TXDOT AVIATION STATEWIDE AIRPORT ELECTRICAL CONSTRUCTION PROJECT (AVSAE) - GROUP ALPHA
TxDOT CSJ No. 4222AVSAEA

ADDENDUM NO. 3

May 14, 2025

4 / EG4.3 **VAULT LIGHTING PLAN**
SCALE: 1/2" = 1'-0"

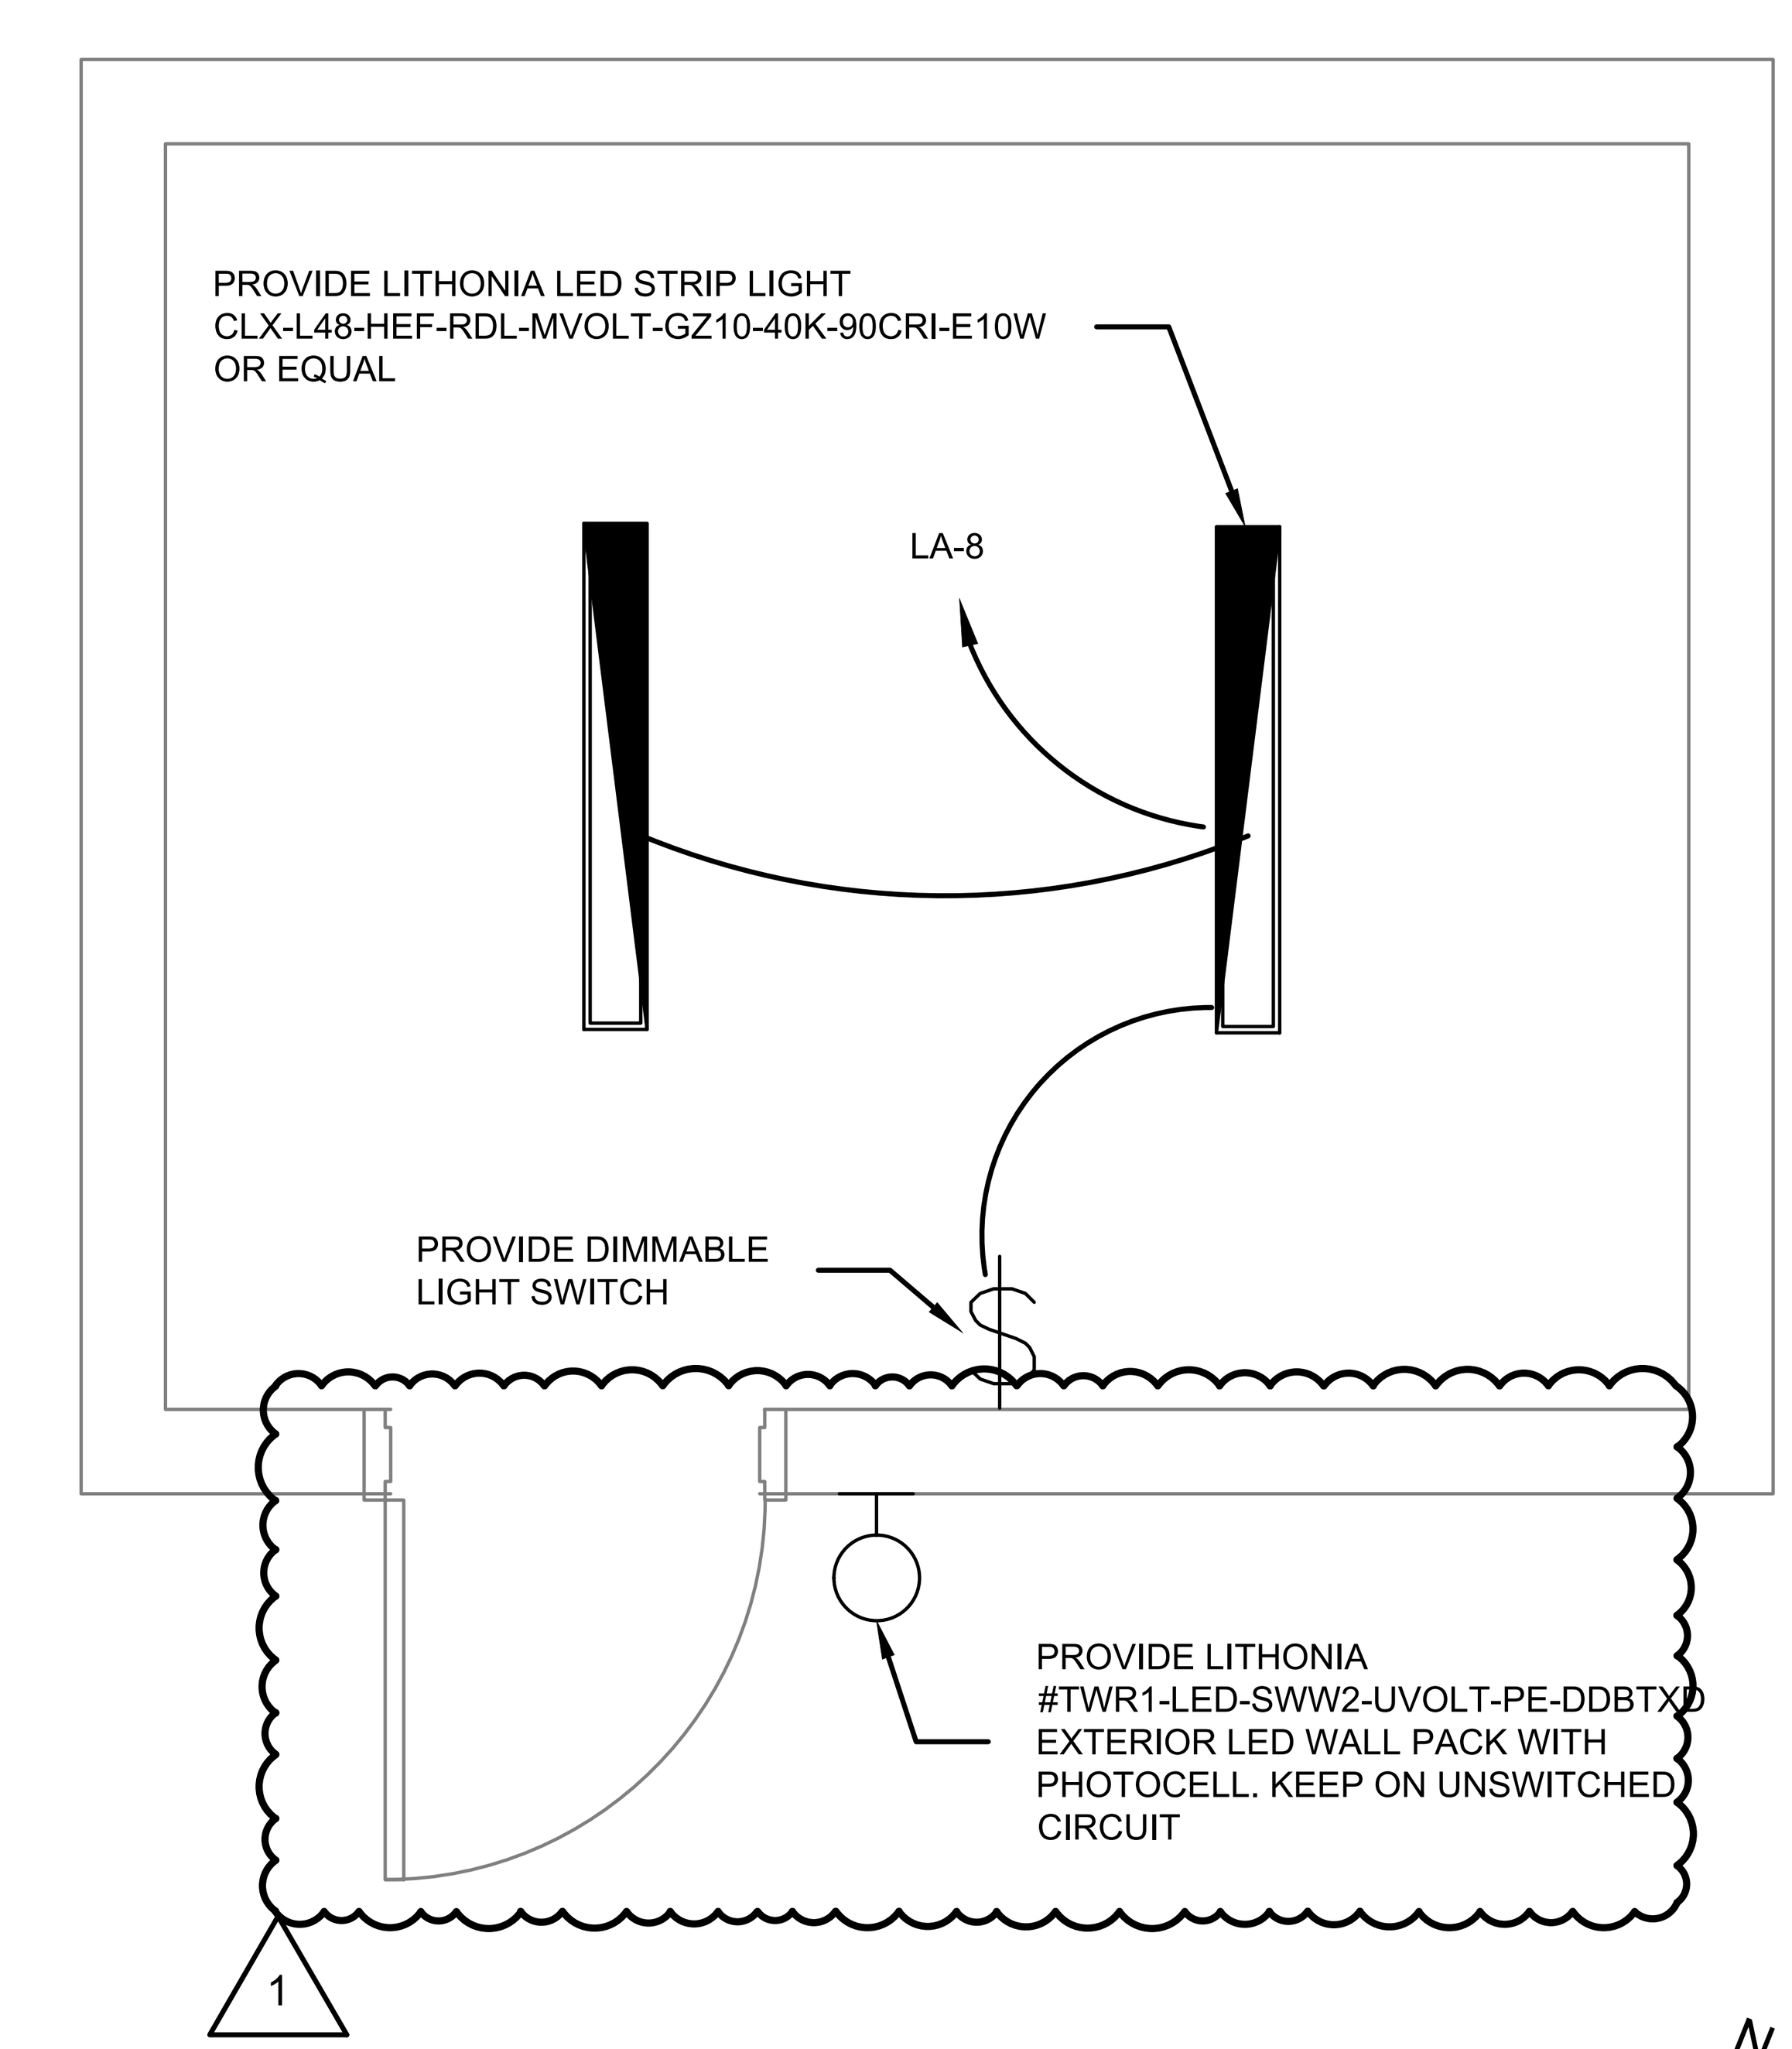
v) **Sheet EG4.3 –Electrical Vault Plan. Revised details to update the vault power plan, vault grounding plan, and vault lighting plan.**
w) **Sheet EG6.1 – Airfield Lighting Schedules. Revised Edge Light Fixture Schedule.**

2 EP4.1 **VAULT PLAN - FRONT ELEVATION**

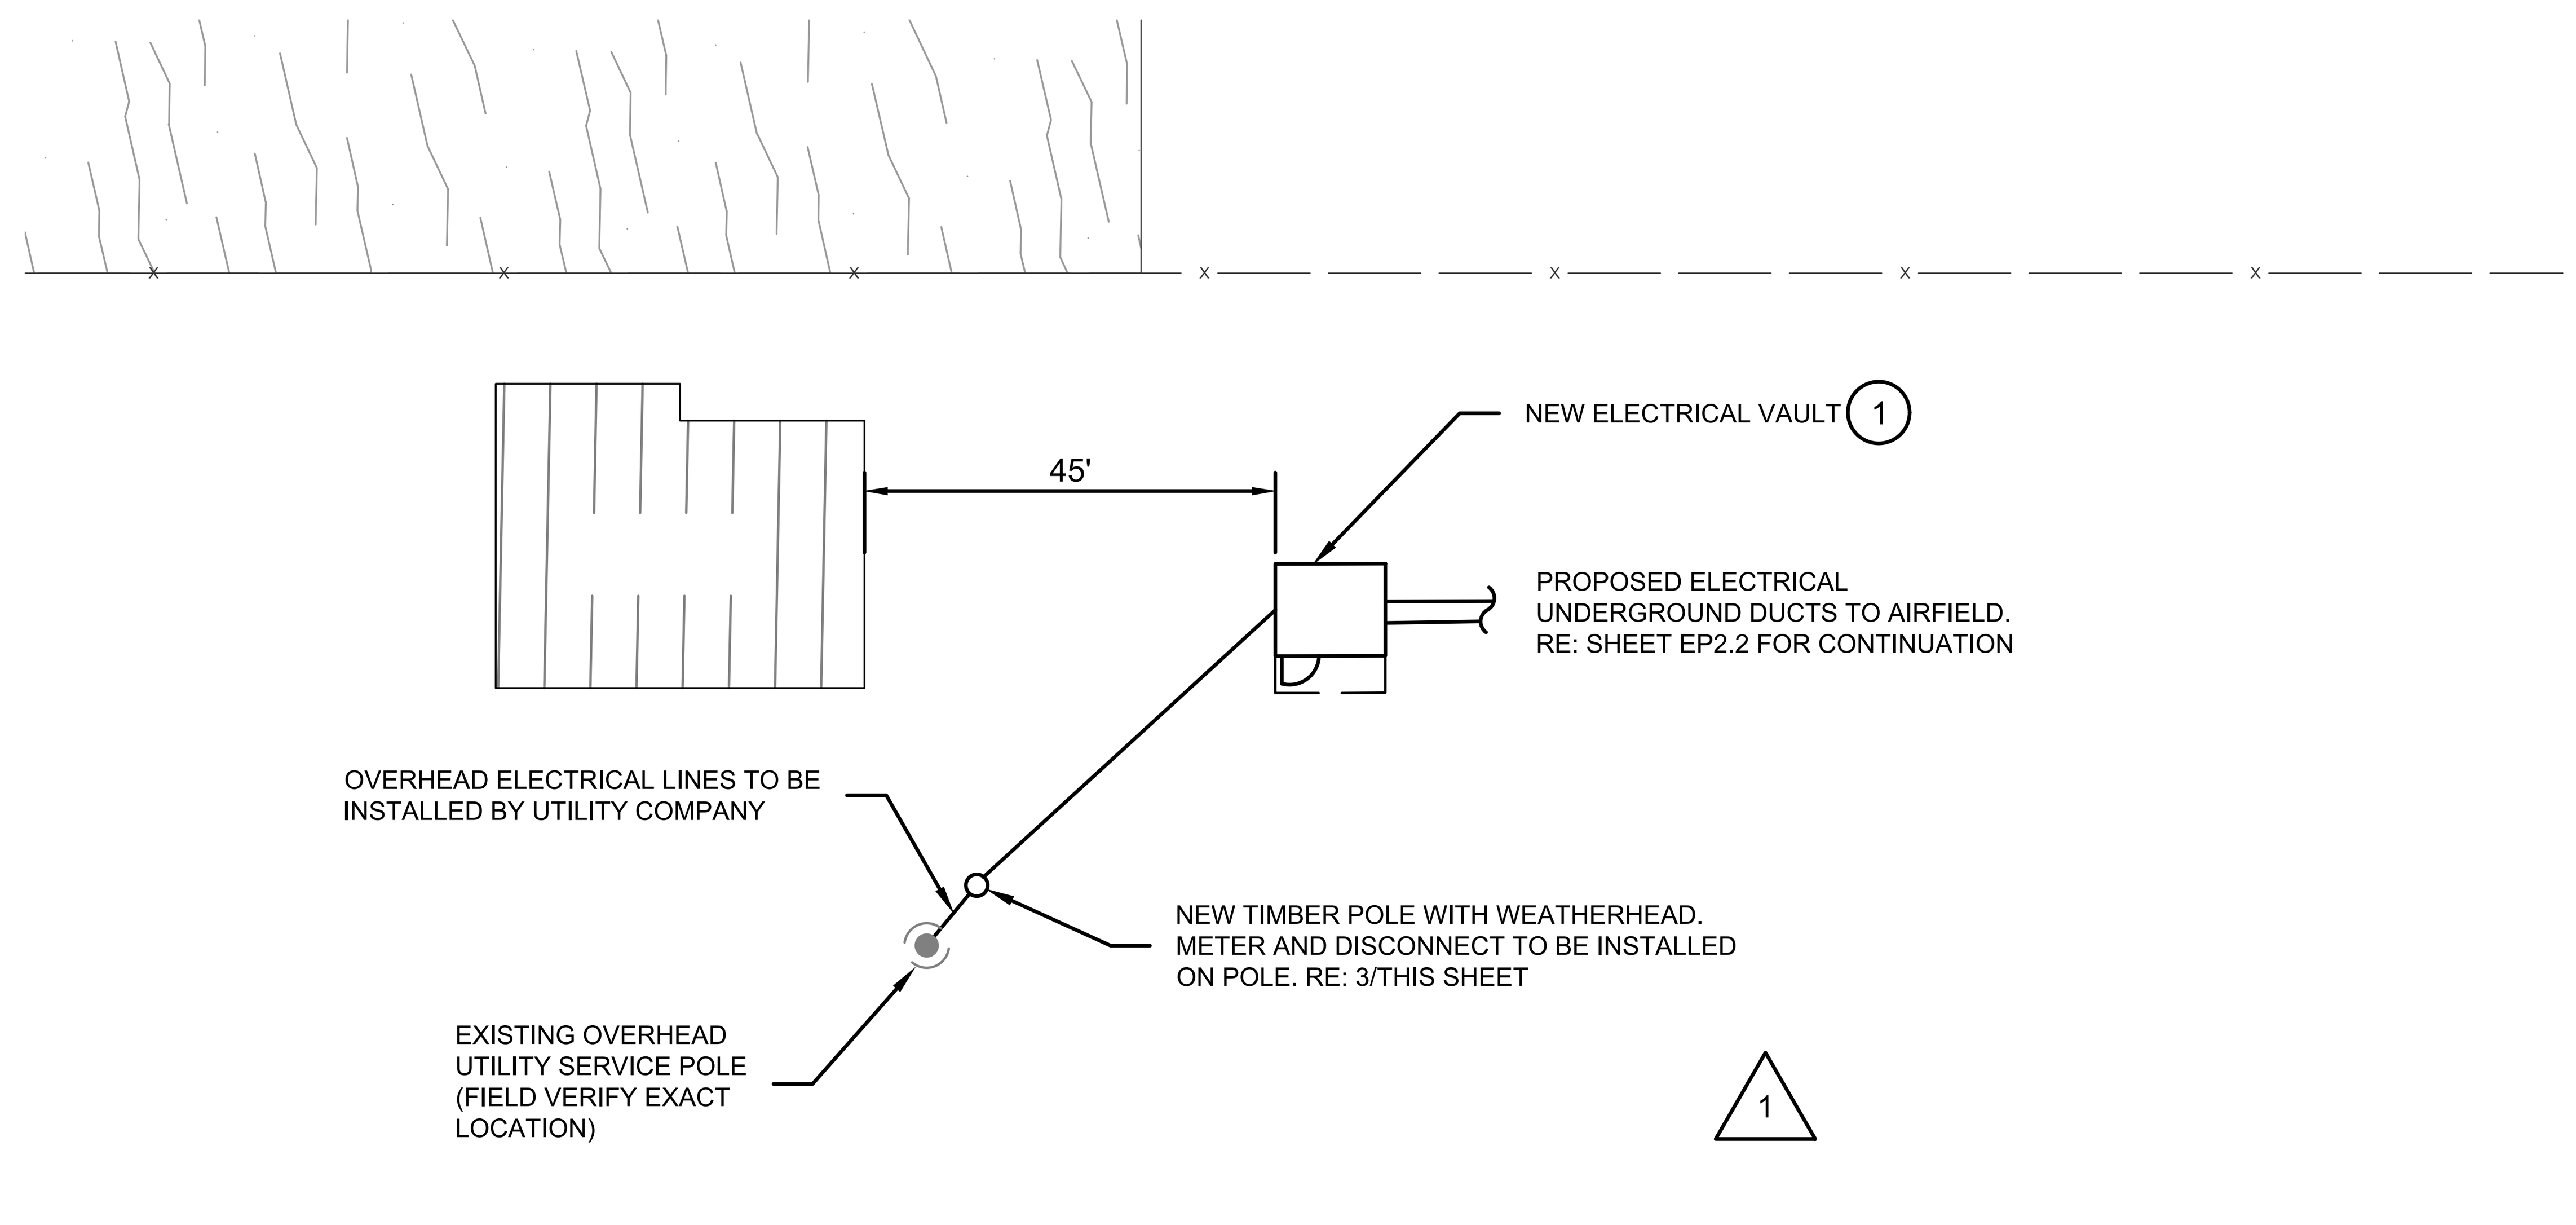
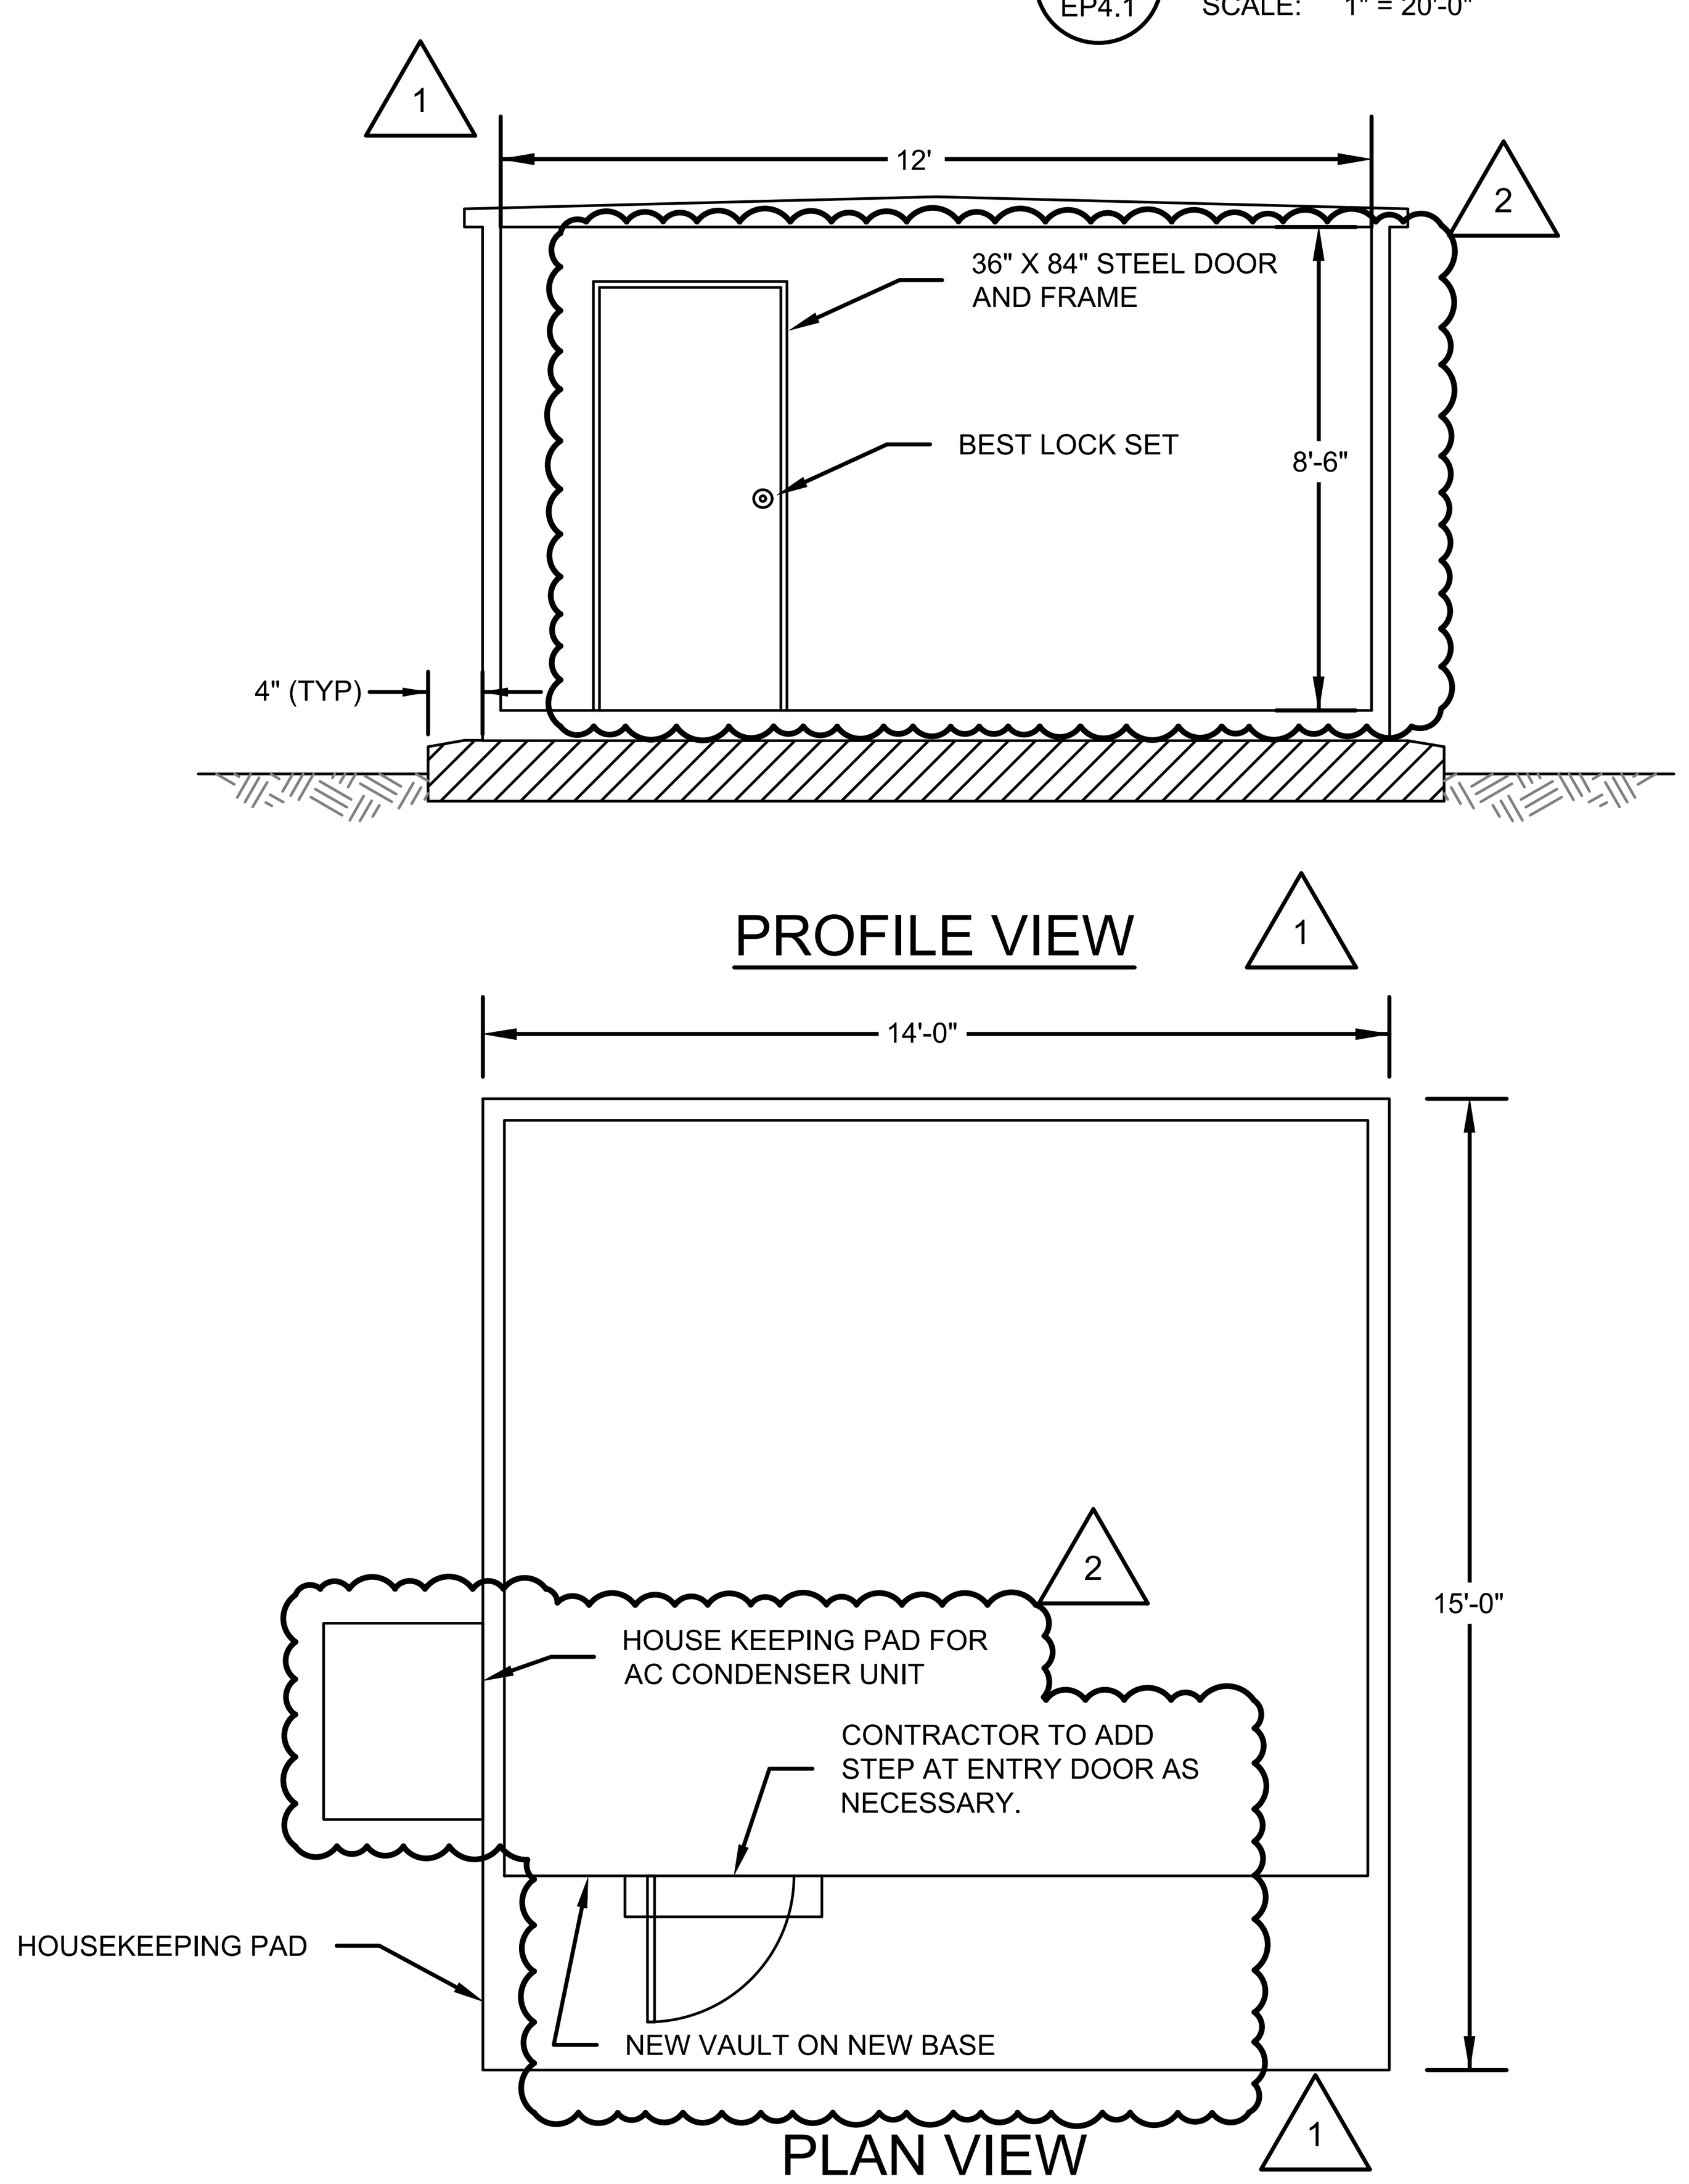
ii) **Sheet EP3.5 – Airfield Electrical Dimension Plan. Revised detail 1 to add dimension for new light fixture.**
jj) **Sheet EP4.1 –Electrical Vault Plan. Revised details to vault front elevation, vault foundation plan, show doorstep, and update keyed note 1 for HVAC verbiage.**
kk) **Sheet EP4.2 –Electrical Vault Plan. Revised details to update the proposed vault plan, wall elevations, and update panel schedule.**
ll) **Sheet EP4.3 –Electrical Vault Plan. Revised details to update the vault power plan, vault grounding plan, and vault lighting plan.**
mm) **Sheet EP6.1 – Airfield Lighting Schedules. Revised Runway Edge Light Fixture schedule.**
nn) **Sheet EP6.2 – Airfield Lighting Schedules. Revised JCP schedule. Revised sign S1-B number of modules.**
oo) **Sheet ER1.2 – Airfield Electrical Demolition Plan. Revised detail 1 to show updated scope.**
pp) **Sheet ER1.7 – Airfield Electrical Demolition Plan. Revised detail 1 to show updated scope and to update note for existing electrical rack.**
